Groundwater Protection and Monitoring Program Plan for Rocky Flats Plant

**Manual No.
21000-MP-GPMP**

GROUNDWATER PROTECTION AND MONITORING PROGRAM PLAN

APPENDIX E COMMENT RESOLUTION FORMS

FIGURE 2-12

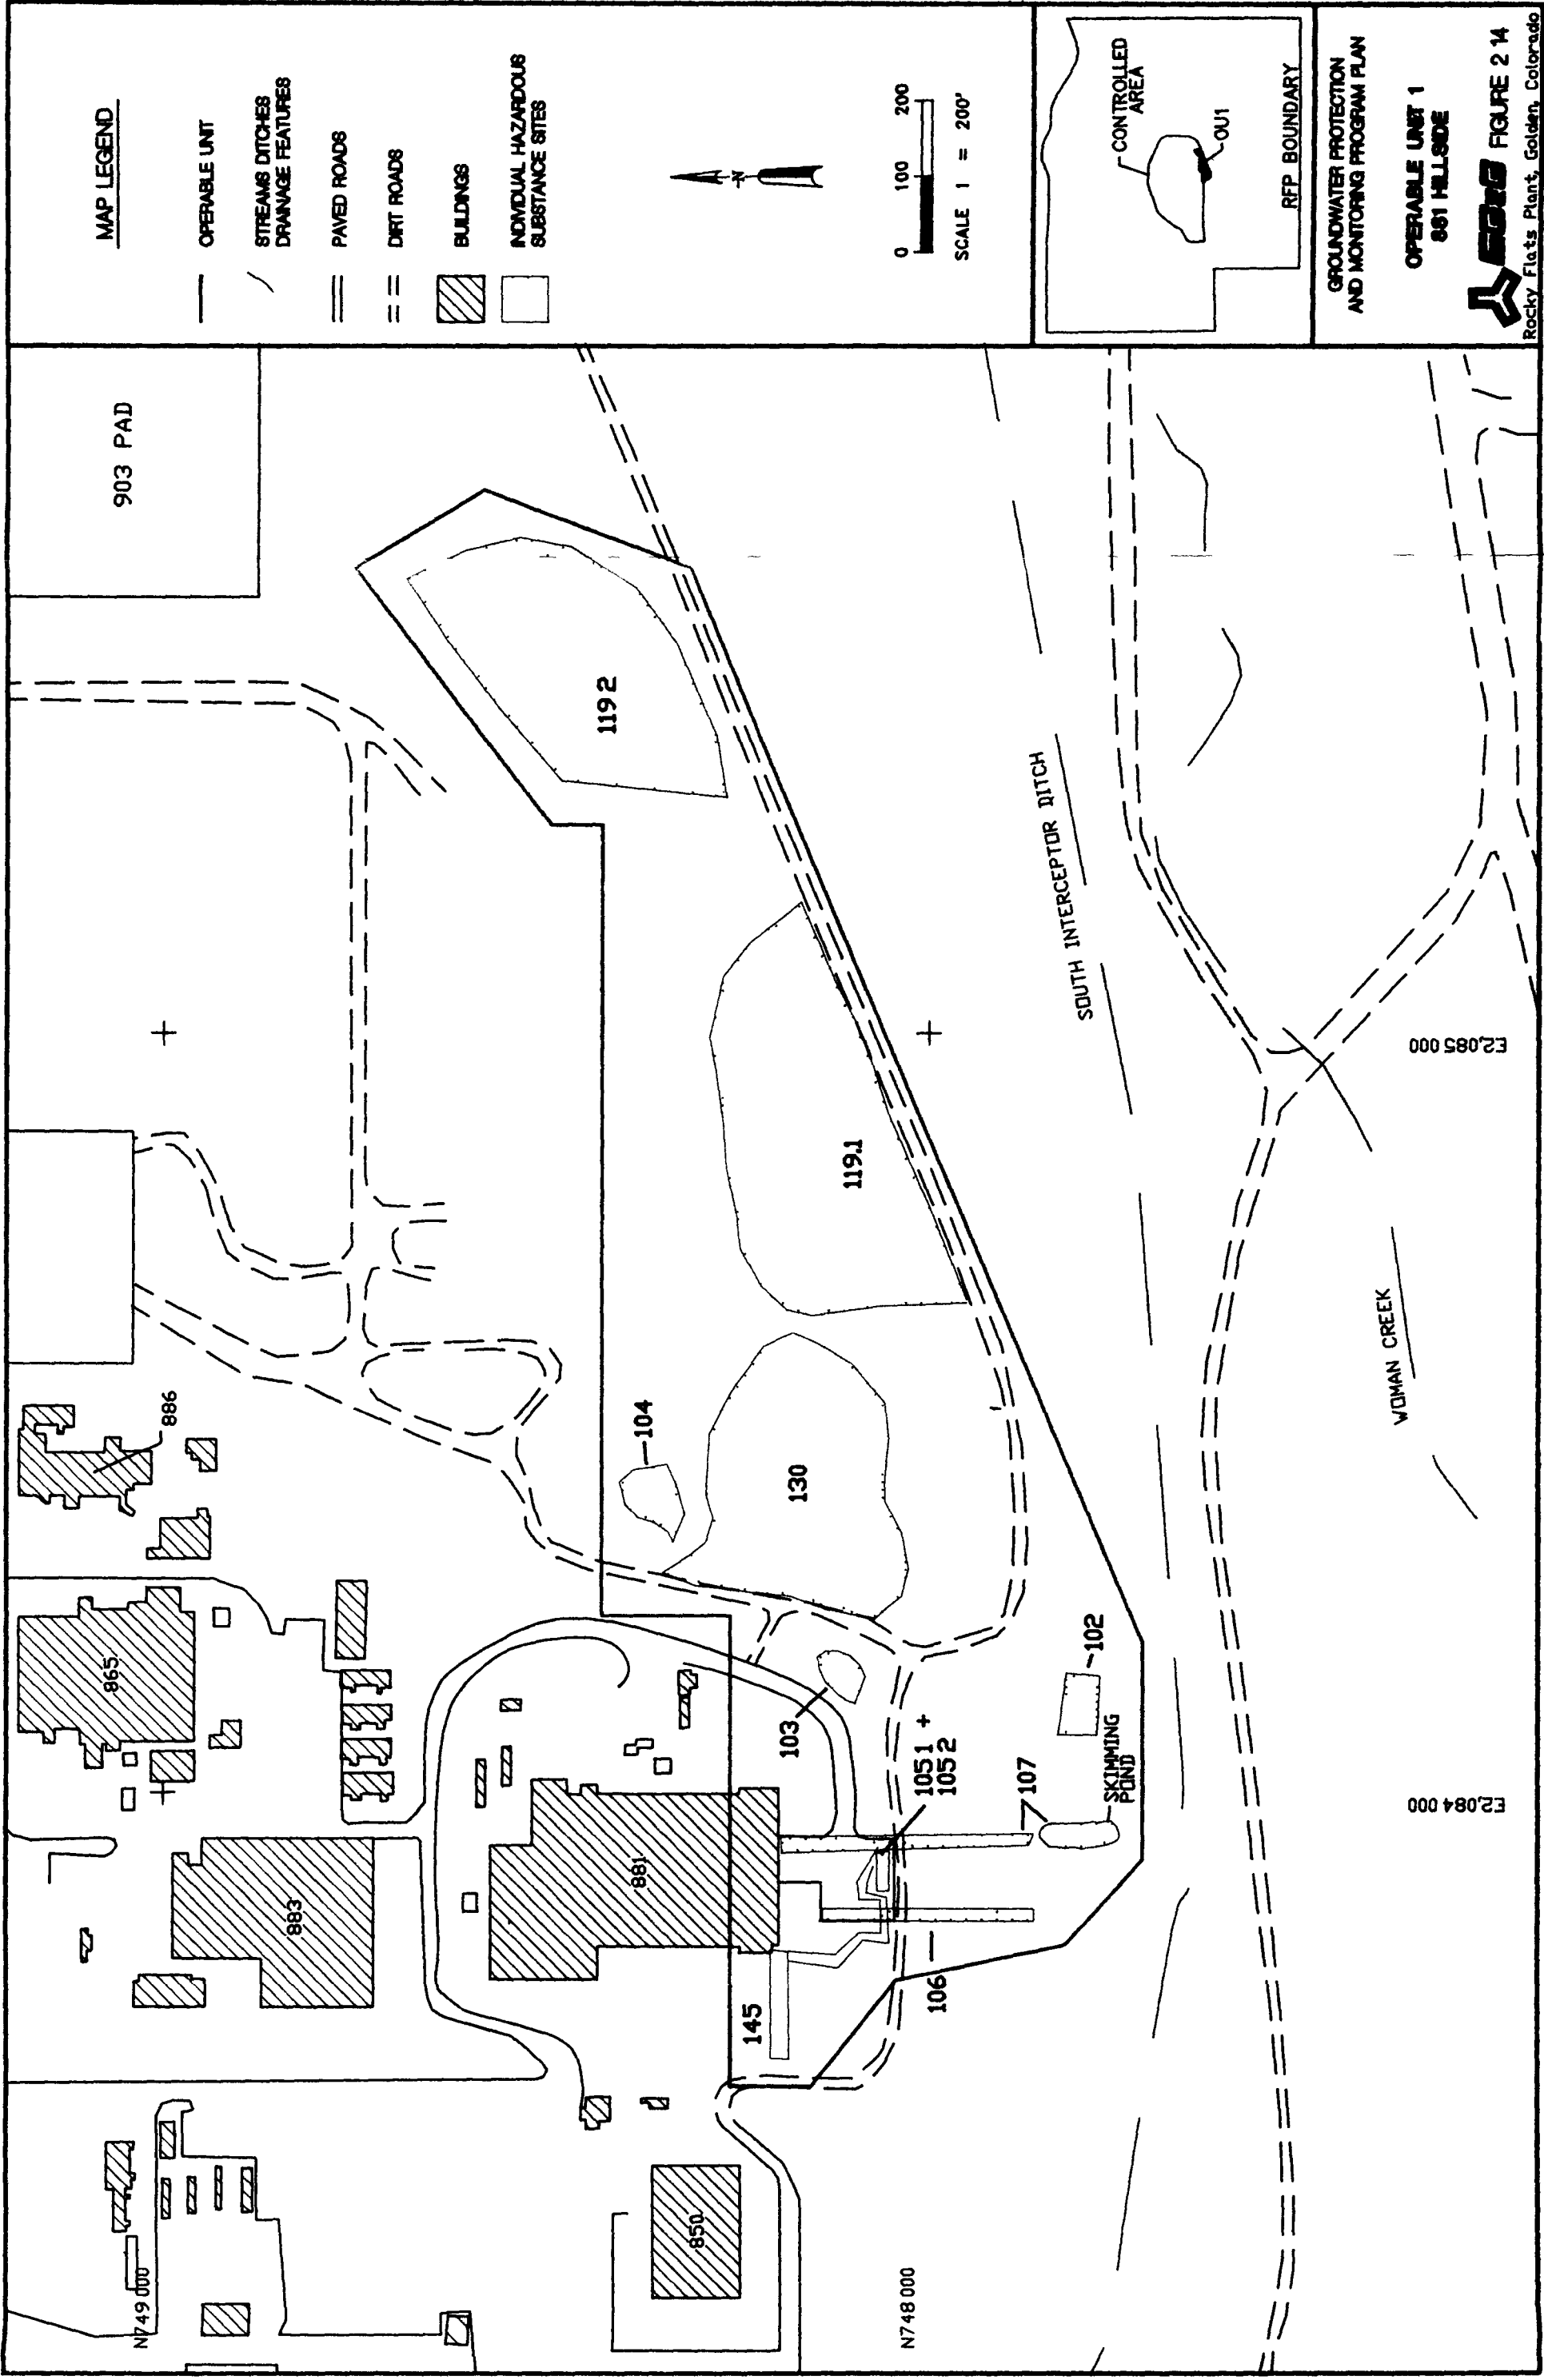
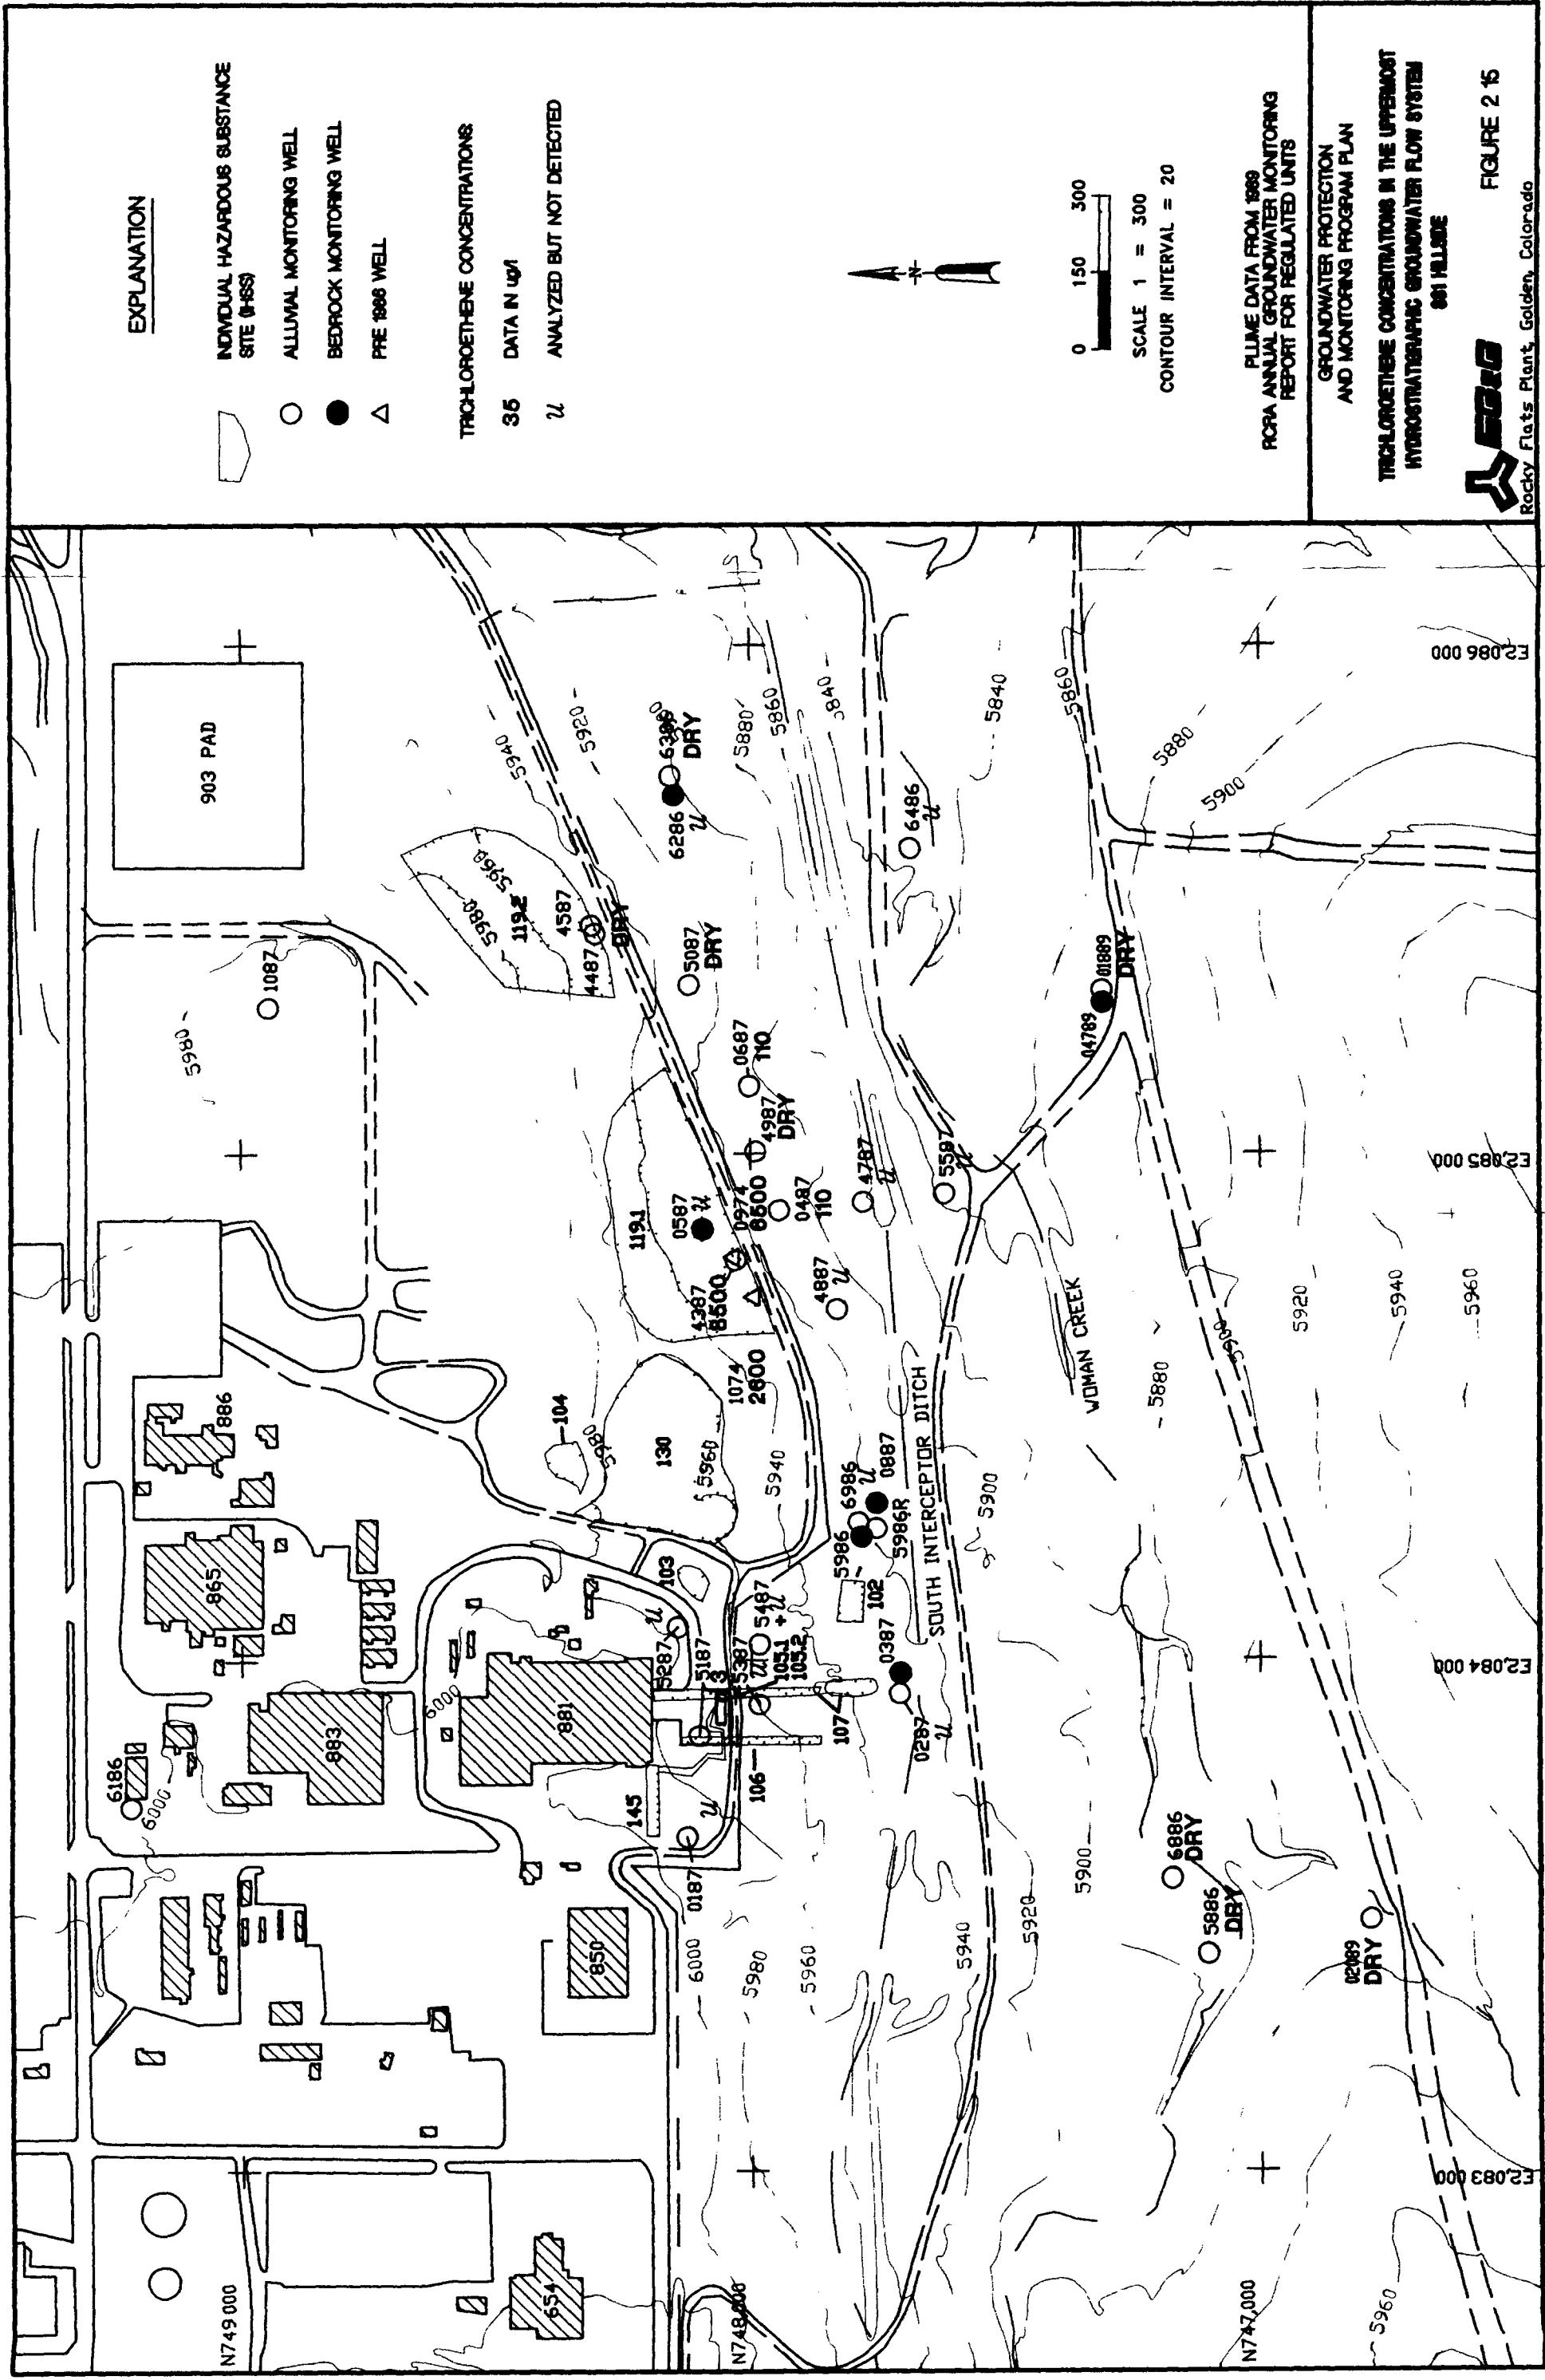
21	Figure 2-12	Connection of isopleths around different IHSSs may be misleading depending on the amount of information that is known between different IHSSs	The figure has been updated with new information
22	2-38	In Table 2-6, the key identifying the geologic units should include SPC	SPC has been dropped from the table
23	2-37	The Background Geochemical Characterization Report should be referenced as the source for the background upper tolerance levels	The source for the background tolerance levels is given on page 2-34. This information will also be added to Table 2-6
24	Table 2-9	In Table 2-9, it is not clear how the average thicknesses were determined for the different geologic units. The average thickness for the sandstone and siltstones is not consistent with those provided earlier in the text. The basis for not calculating water stored in the Arapahoe claystone is not justified. This could provide useful information.	Because on-site data for the Arapahoe Formation, and deeper geologic units beneath RFP, are not generally available, the average thicknesses and saturated thicknesses of these geologic units were taken from Colorado State Engineer publications. These values agree quite well with the composite sandstone thickness present on average at RFP.
